CITY OF MADISON
CITY ENGINEERING DIVISION
DEPARTMENT OF PUBLIC WORKS
PLAN OF PROPOSED IMPROVEMENT

1 & 15 ELLIS POTTER COURT

CITY PROJECT NO. 15157
CONTRACT NO. 9514

REVISION 1 - 08/05/25
- UPDATED SHEETS: P1, U1, L1

15157	MADISON, WI	9514	CONTRACT NO:
PLAN & PROFILE - ELLIS POTTER COURT			
1 & 15 ELLIS POTTER COURT			
M:\DESIGN\Projects\15157\CAD\Streets\15157\EN-PnP.dwg			
15157			
P-1

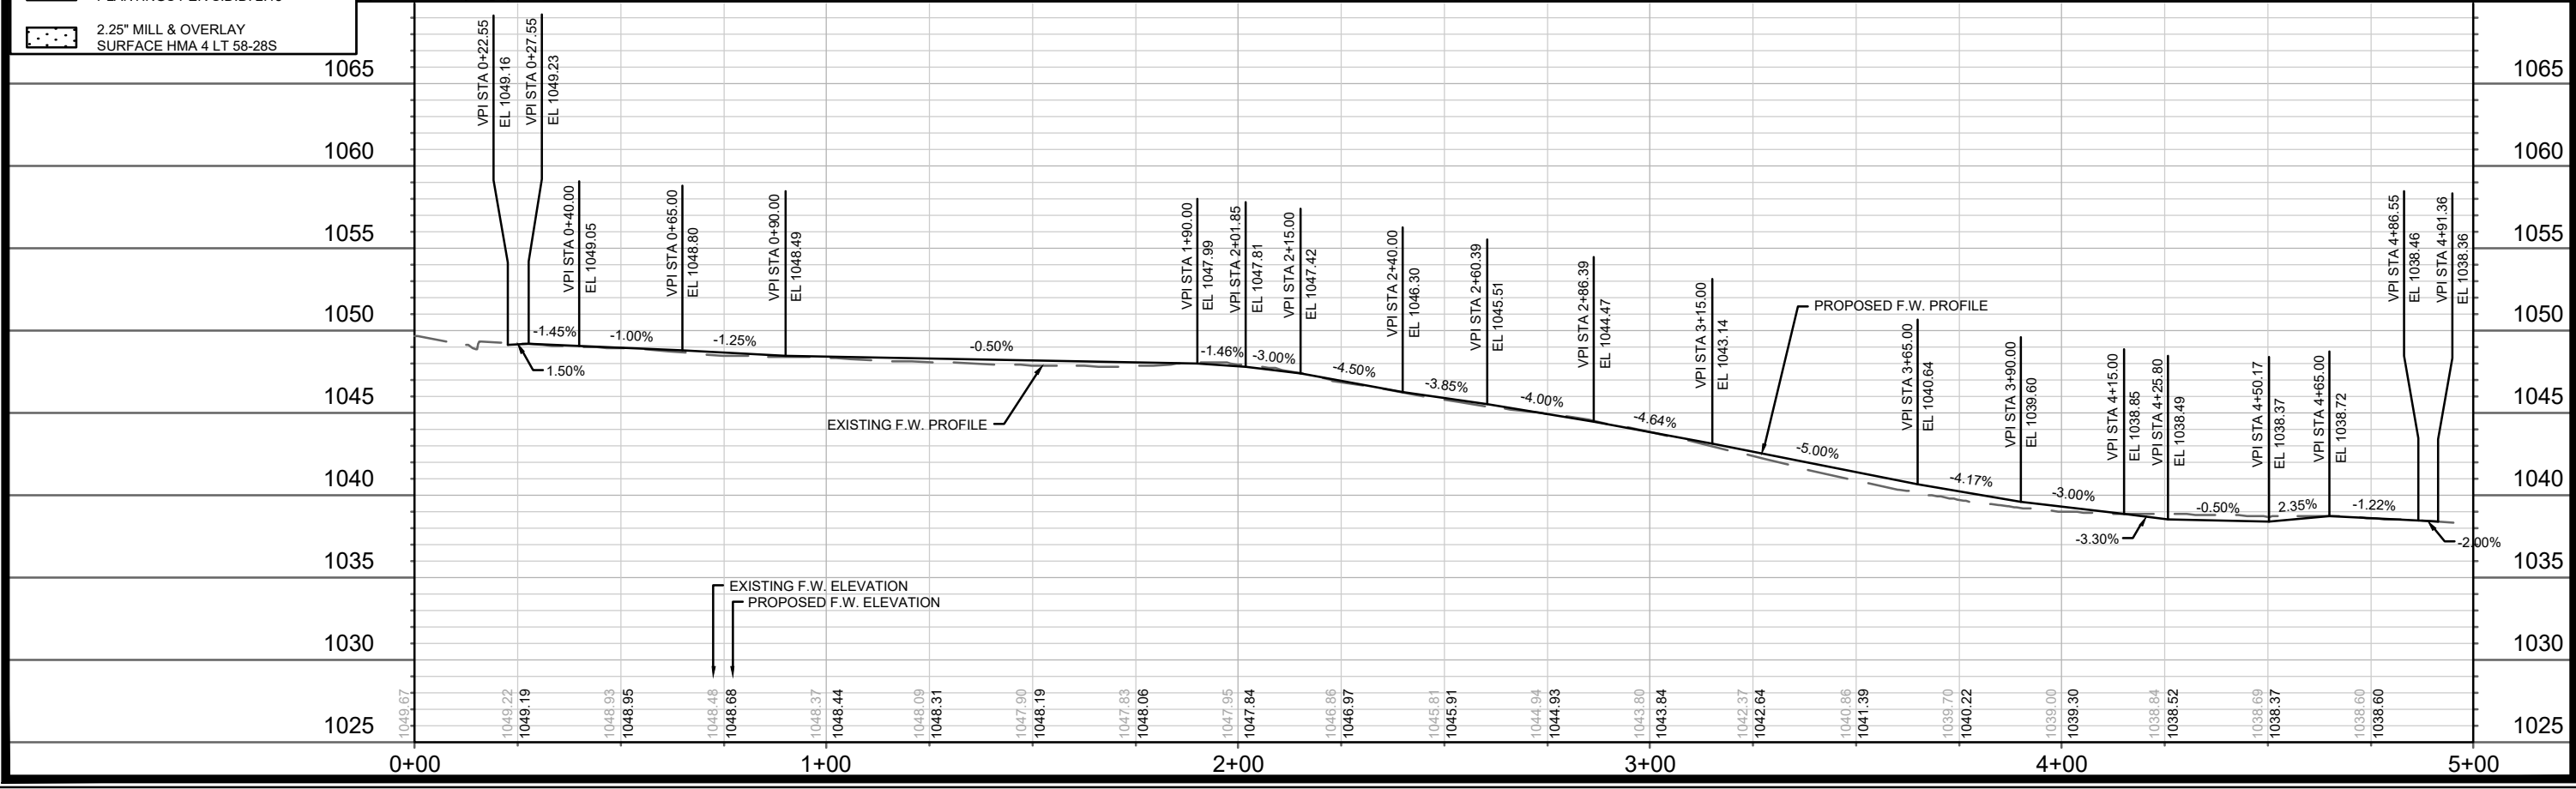
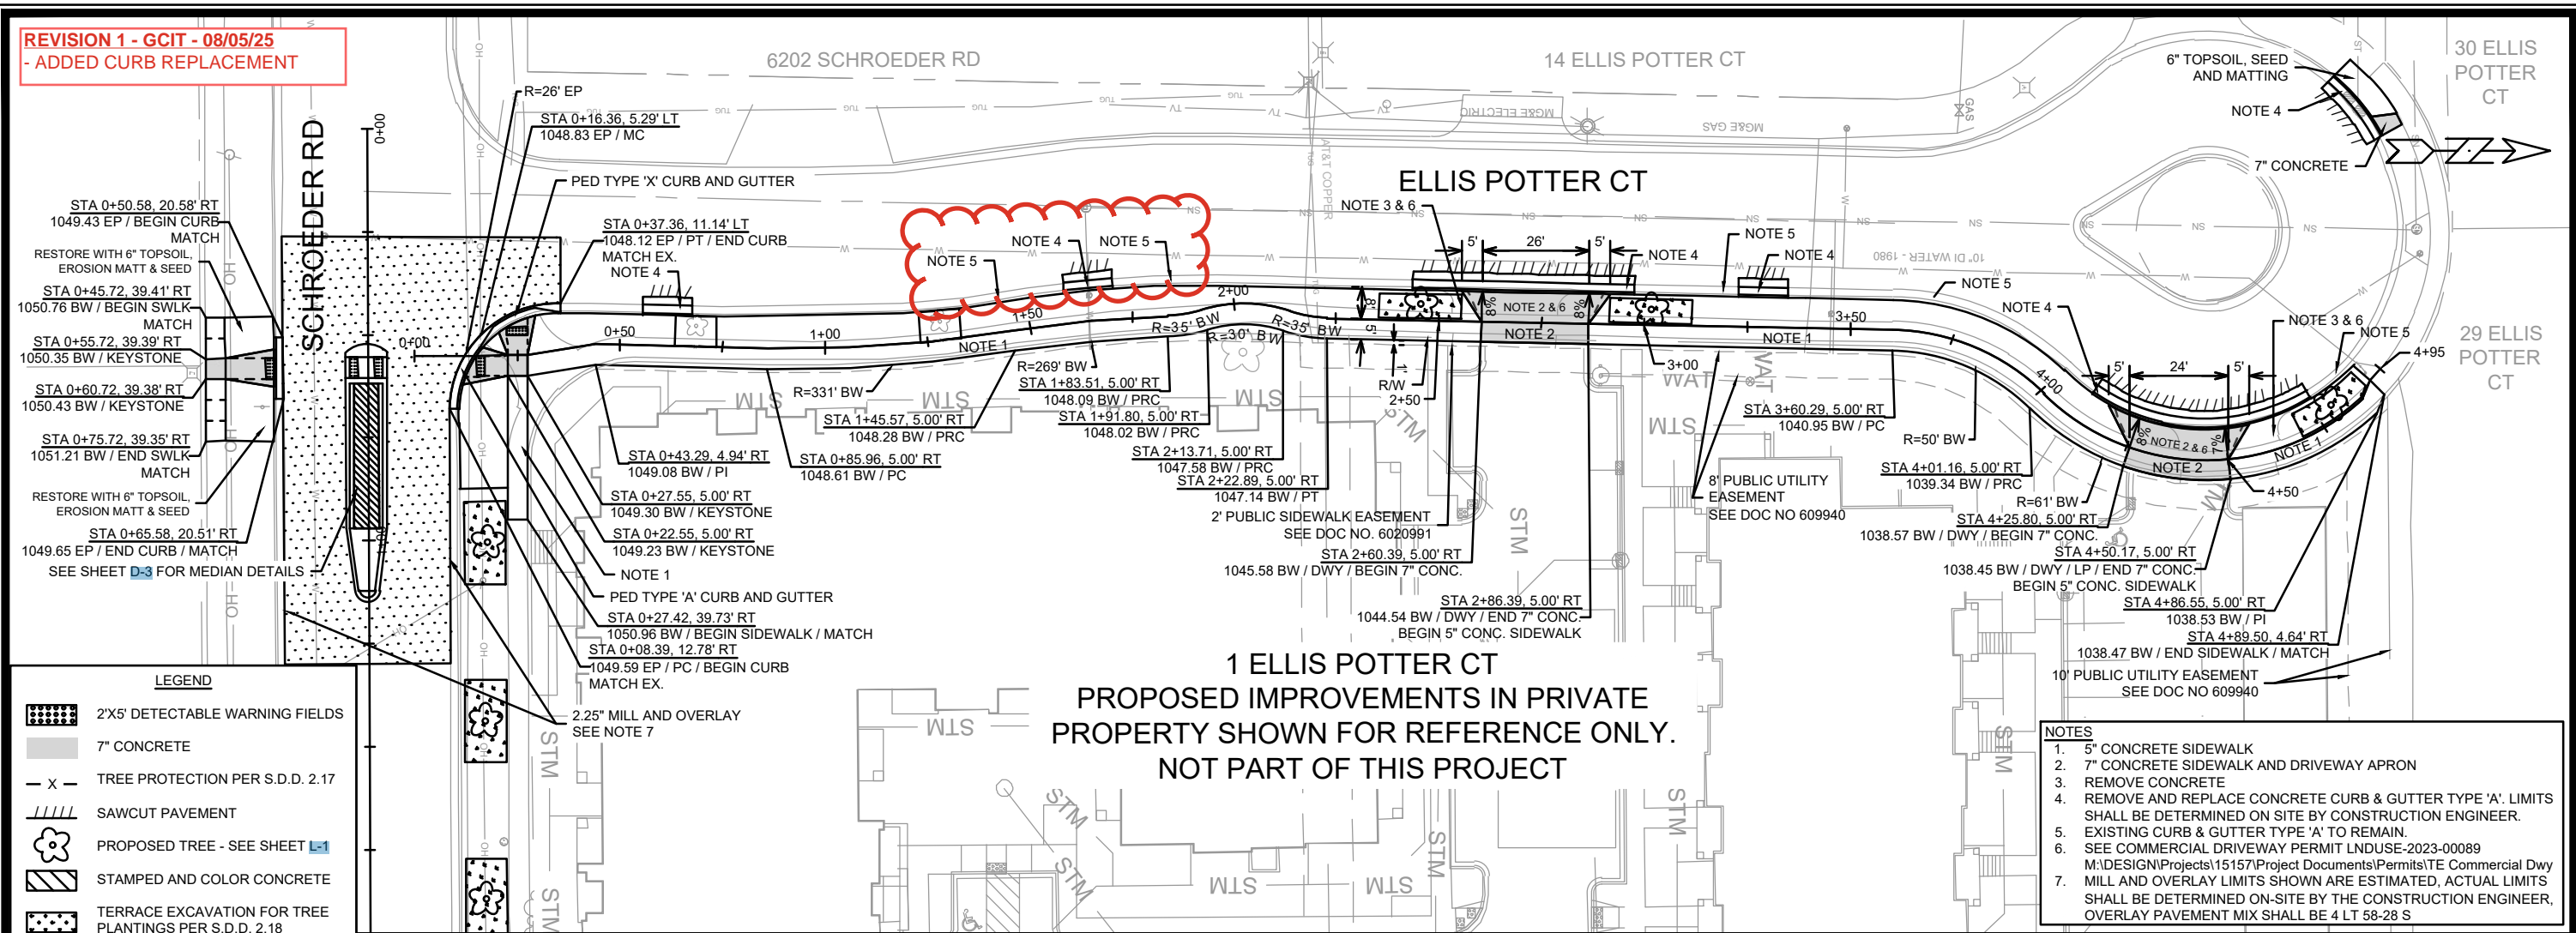
REVISION 1 - GCIT - 08/05/25
- ADDED CURB REPLACEMENT

15157
MADISON, WI
CONTRACT NO: 9514
UTILITY PLAN
1 & 15 ELLIS POTTER COURT
M:\DESIGN\Projects\15157\CAD\Sewers\15157SWR-PipeNetwork.dwg
15157
U-1

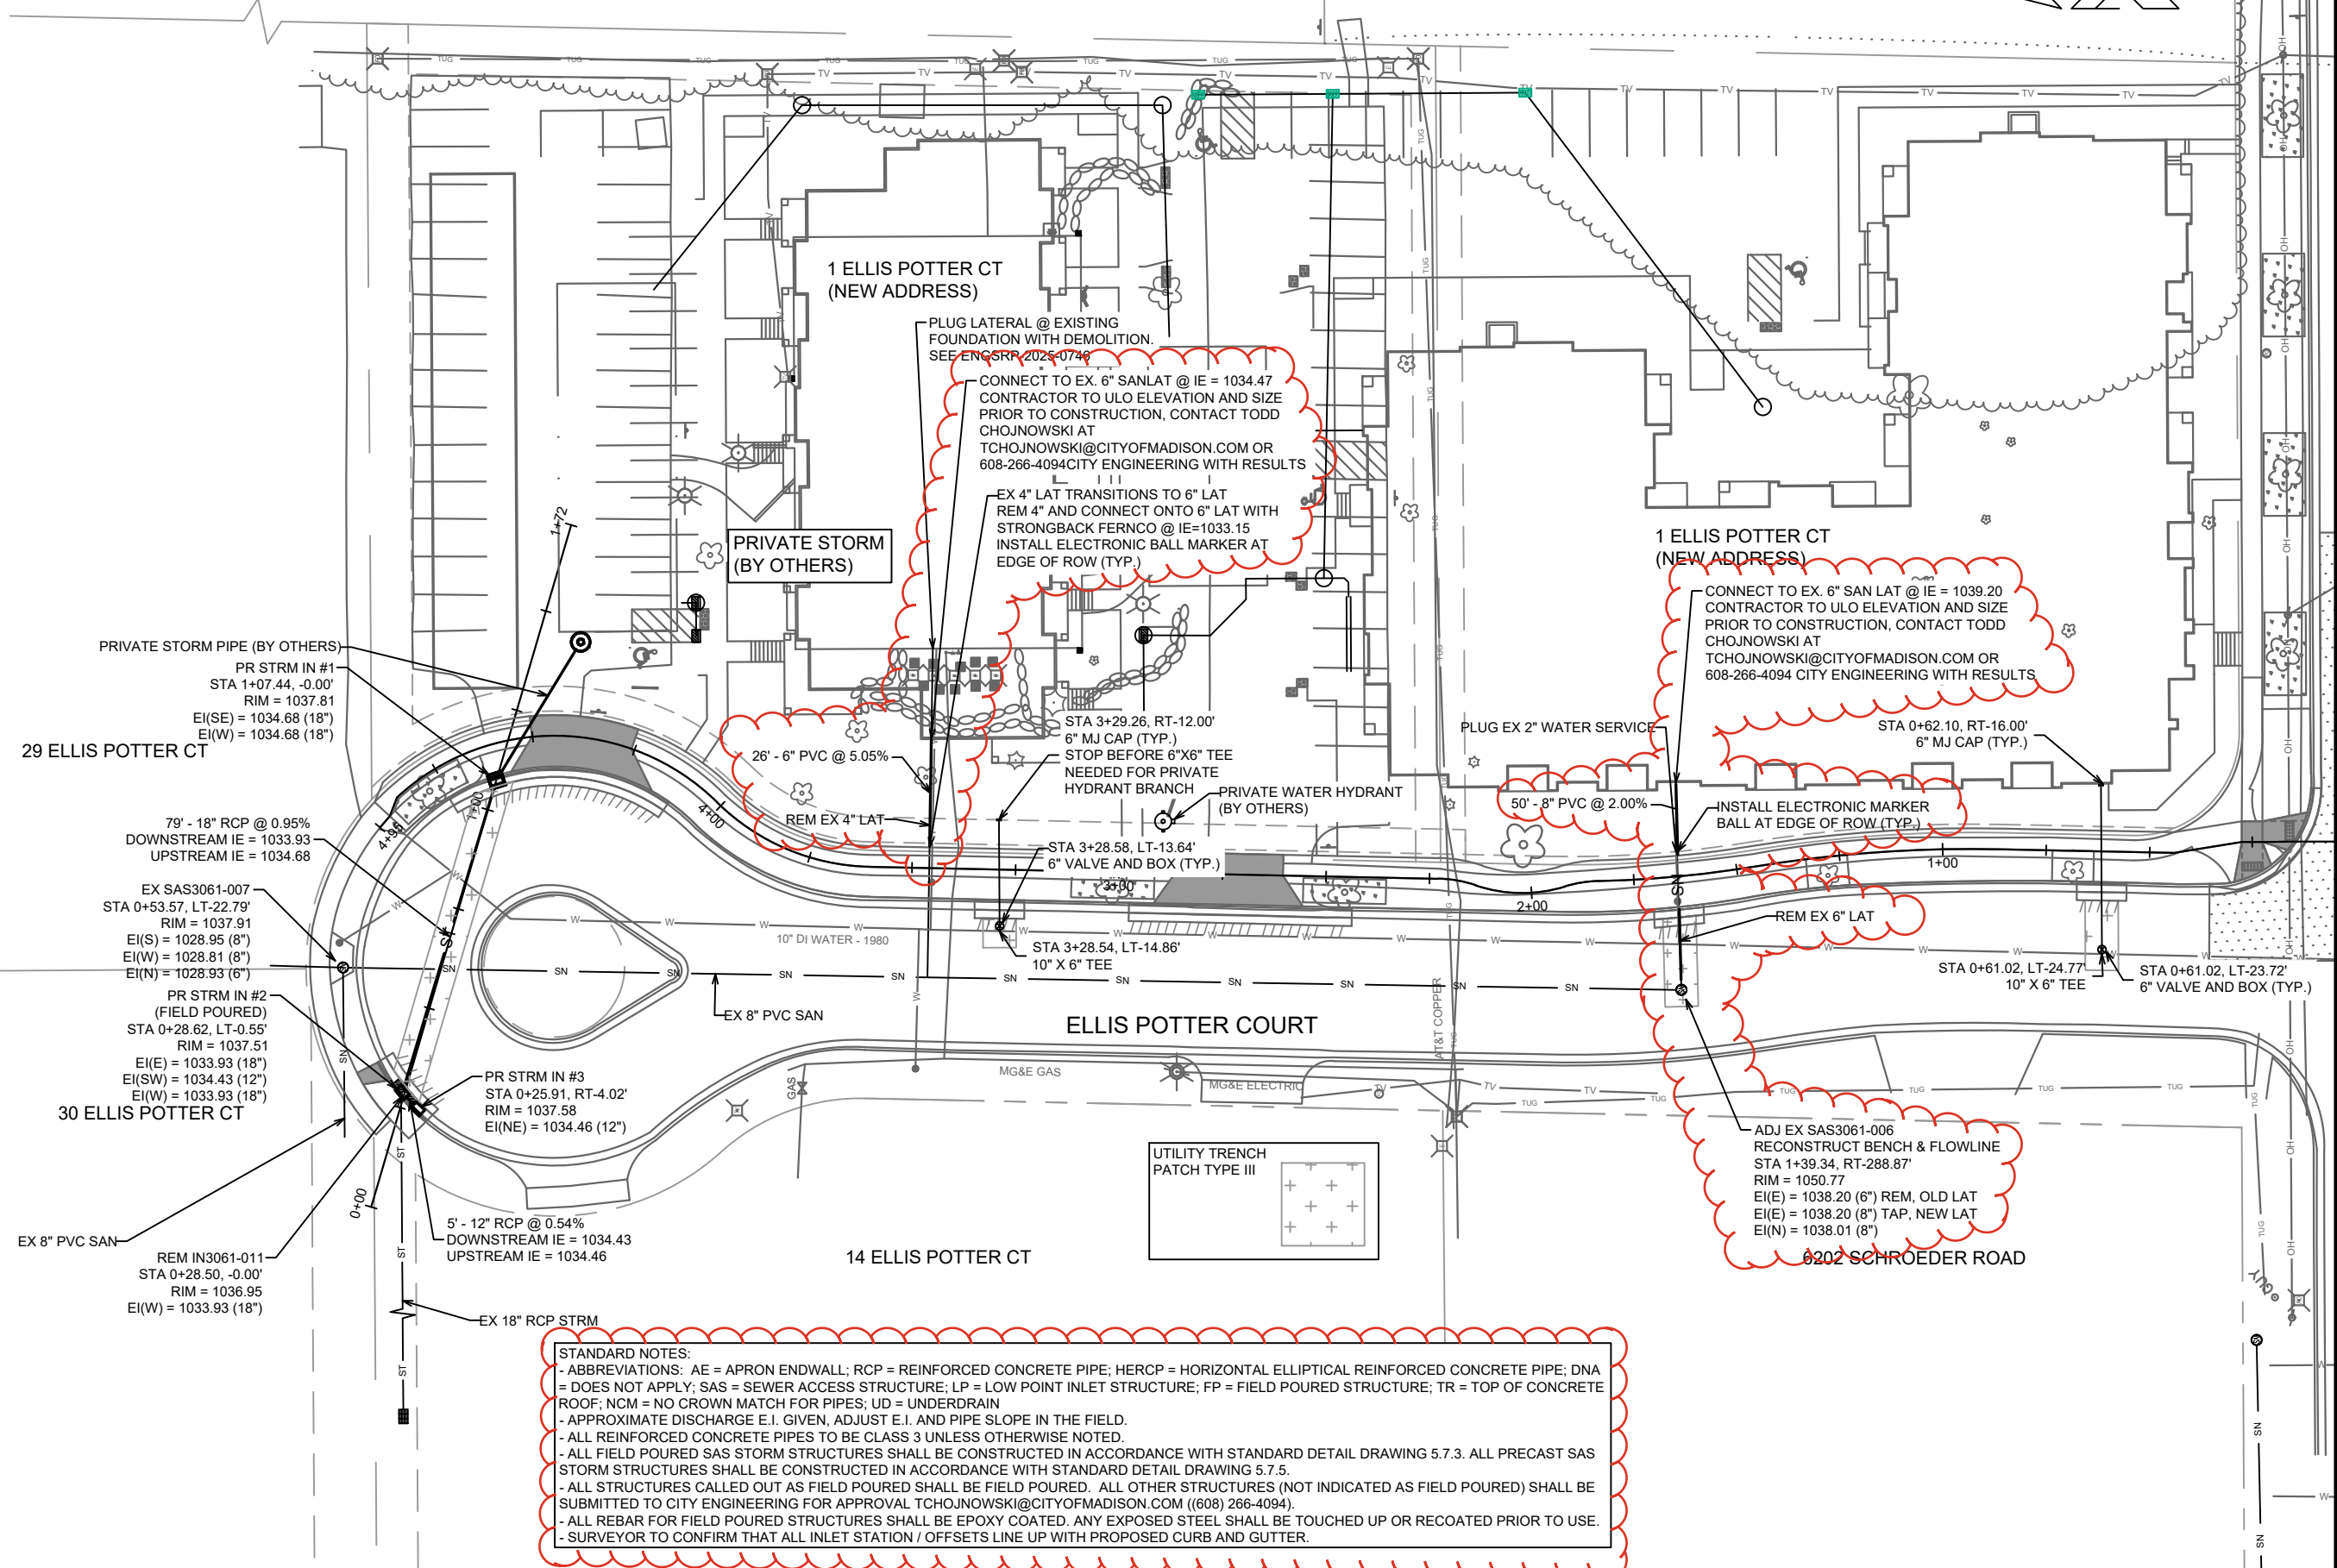
REVISION 1: TAC 8/5/2025
UPDATED SAN LATS
STANDARD UTILITY NOTES
